ADDENDUM

PROJECT: Bryan Health
Bryan Medical Center, West
Independence Center, New Facility
Lincoln, Nebraska

AD-2

DATE ISSUED: Friday, March 22, 2013

SHEET NUMBER
E2-1F

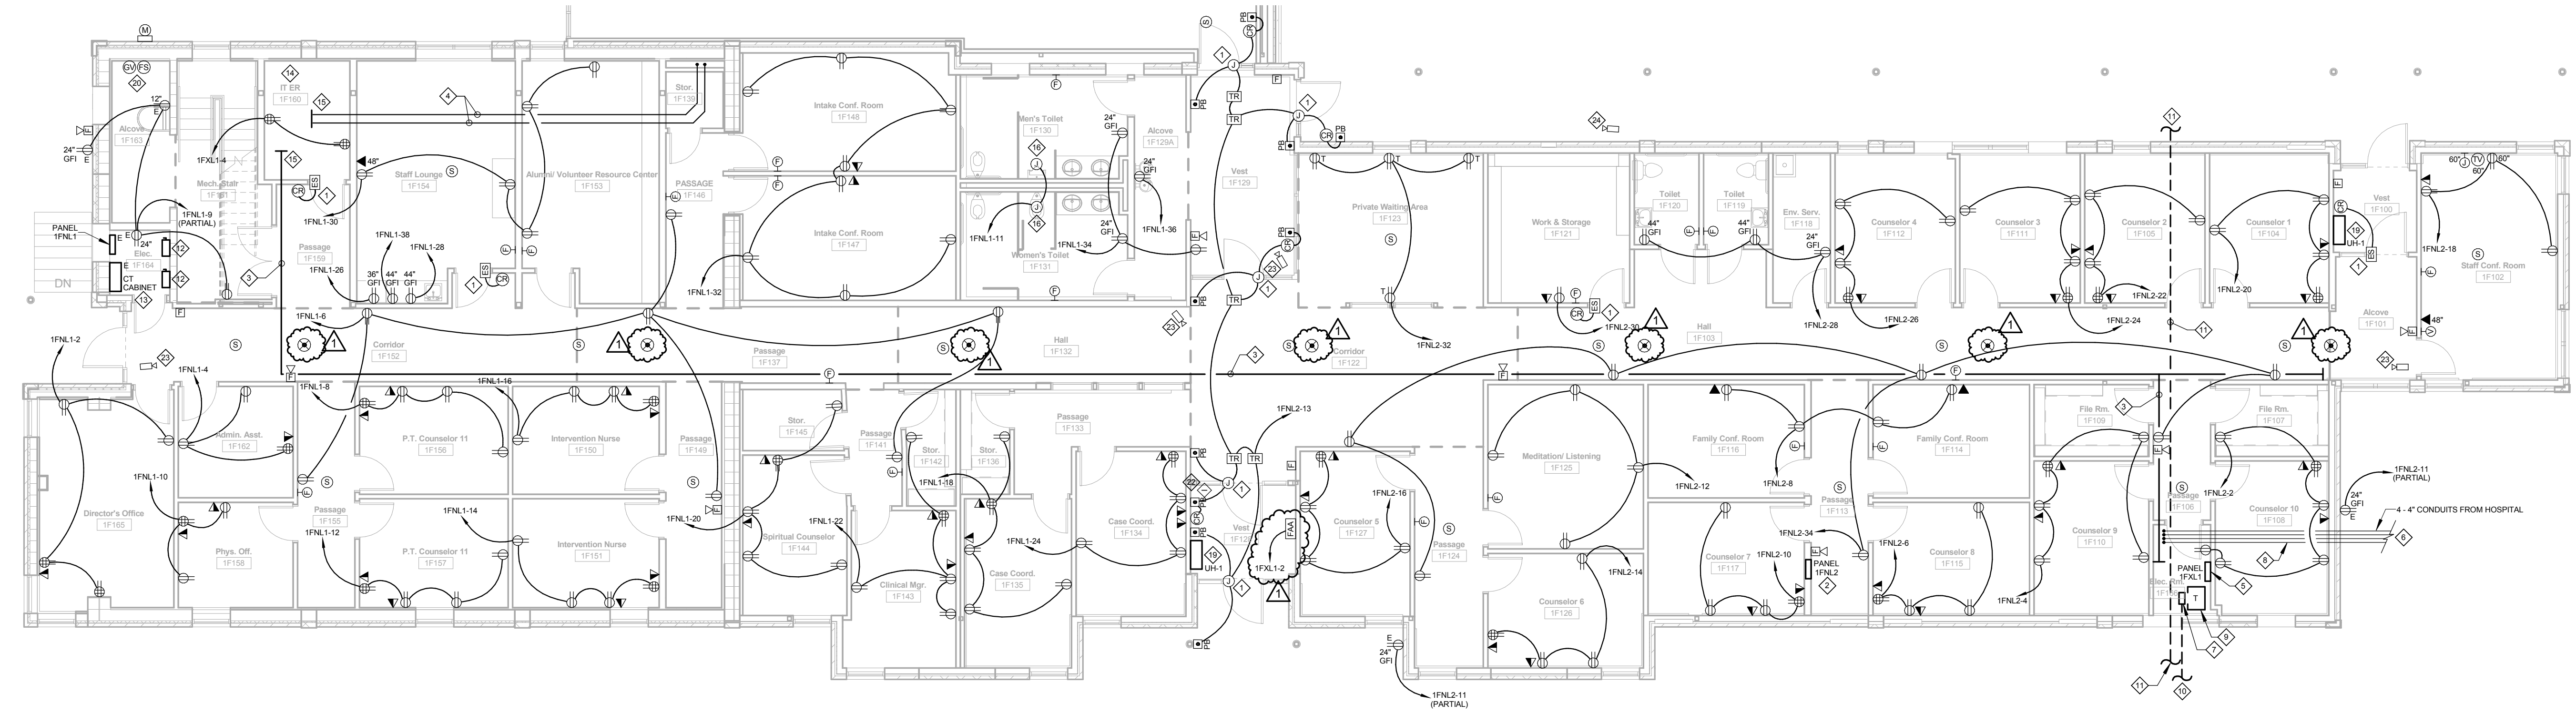
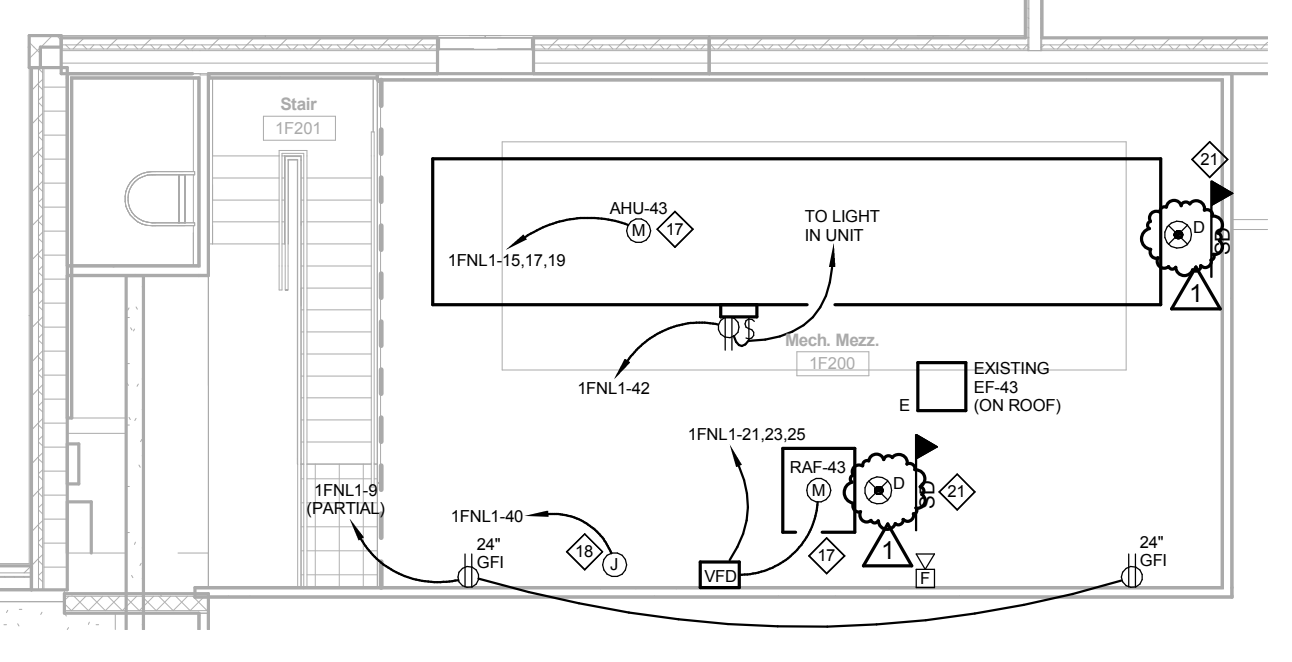
In reference to drawing Sheet E2-1F, First Level Power and Systems Plan – Area F, see attached plan E2-1F for revisions to add fire alarm devices. Note that this is a revised full size sheet.

1 First Level Power and Systems Plan - Area G
1/8" = 1'-0"

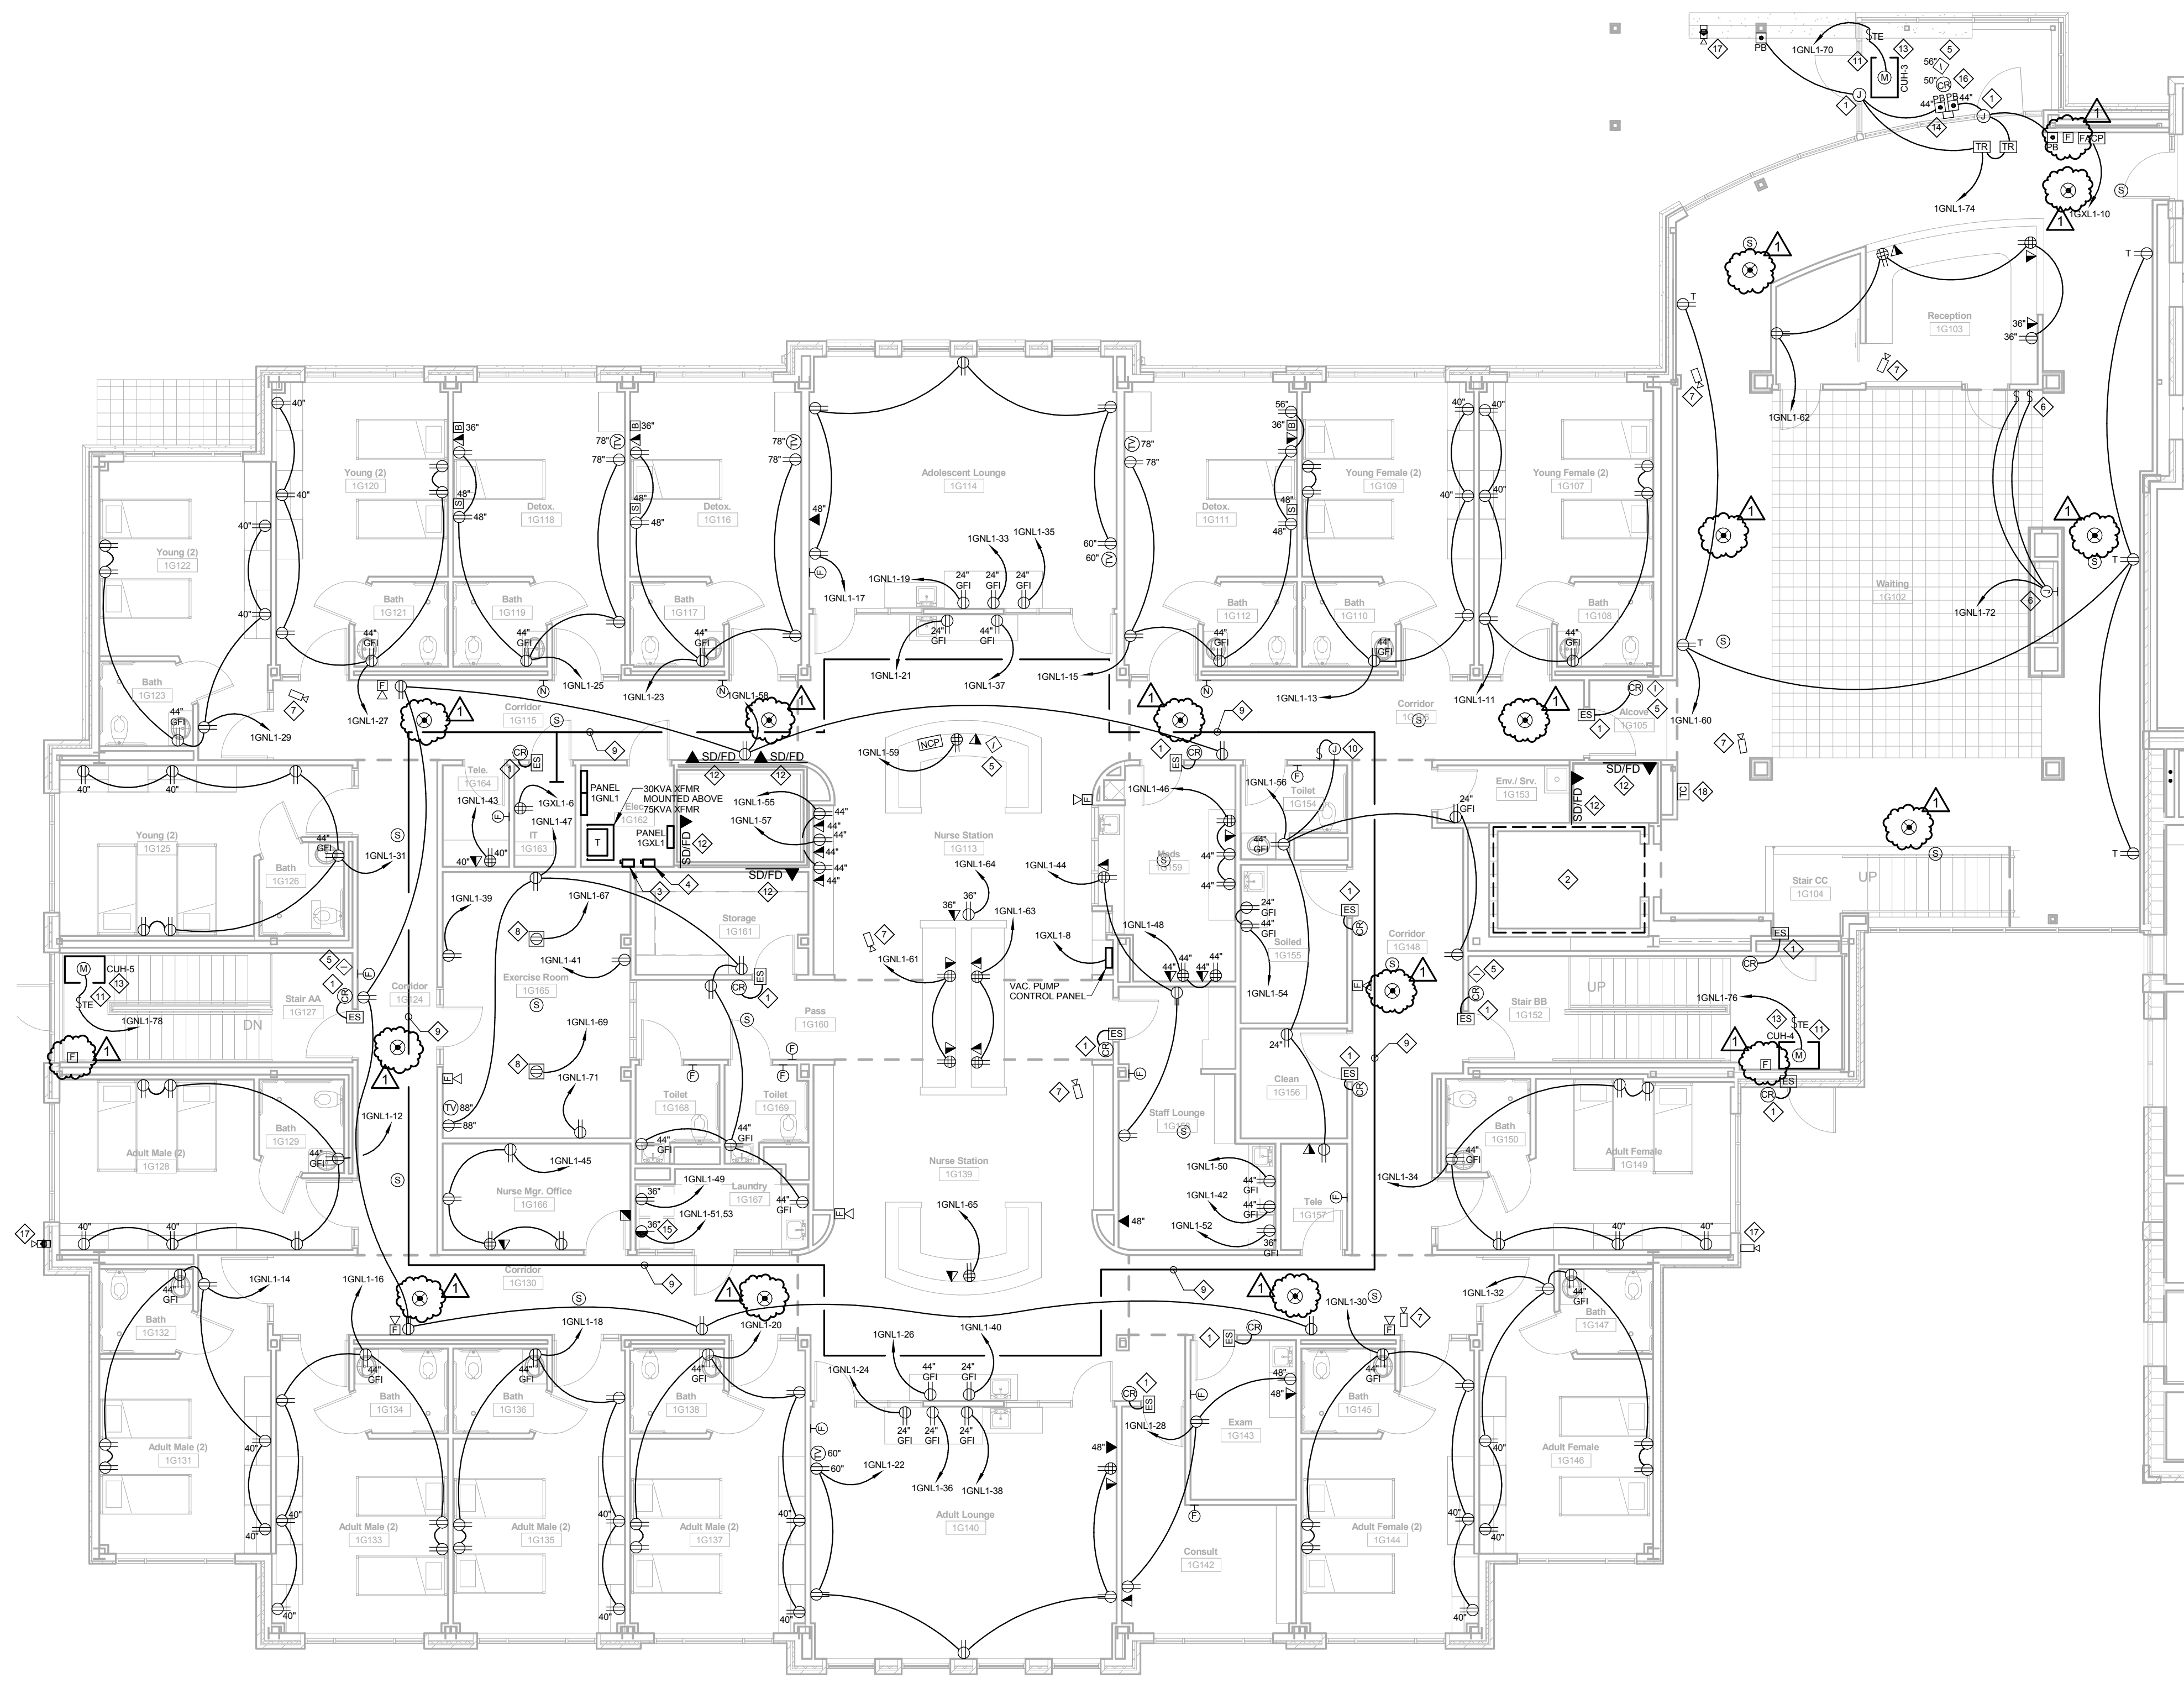
In reference to drawing Sheet E2-1G, First Level Power and Systems Plan – Area G, see attached plan E2-1G for revisions to add fire alarm devices. Note that this is a revised full size sheet.
